TECHNICAL SERVICE BULLETIN

73/A/1

Steel Engine Fan
Replaced by Plastic Fan

MGB & GT

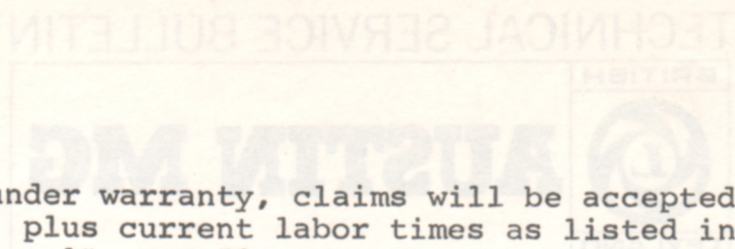
At the following vehicle identification numbers, the six blade steel engine cooling fan, used on MGB and GT Models, was replaced by a seven blade plastic fan:

If it becomes necessary to replace the steel fan on any 1972 or later MGB, (i.e., any engine with an 18V prefix to the number), use this new plastic fan with applicable securing bolts and washers.

Prior to 1972 vehicles (18V Engines), the plastic fan cannot be fitted, as the water pump body is longer and the separate aluminum spacer between the fan and pulley was not used. It will be necessary, therefore, to continue to use the steel fan on '68 through '71 vehicles.

<u>-----STEEL FAN-----</u>			<u>-----PLASTIC FAN-----</u>		
<u>DESCRIPTION</u>	<u>PART #</u>	<u>QTY.</u>	<u>DESCRIPTION</u>	<u>PART #</u>	<u>QTY.</u>
Fan	AHH6999	1	Fan	12H4230	1
Spacer (Between fan and pulley)	12H3910	1	Spacer (Between fan and pulley)	<u>NOT REQUIRED</u>	
Securing Bolt	HZS416	4	Securing Bolt	HZS0407	4
Spring Washer	LWZ304	4	Spring Washer	<u>USE THOSE REMOVED FROM STEEL FAN</u>	
			Plain Washer	PWZ104	4
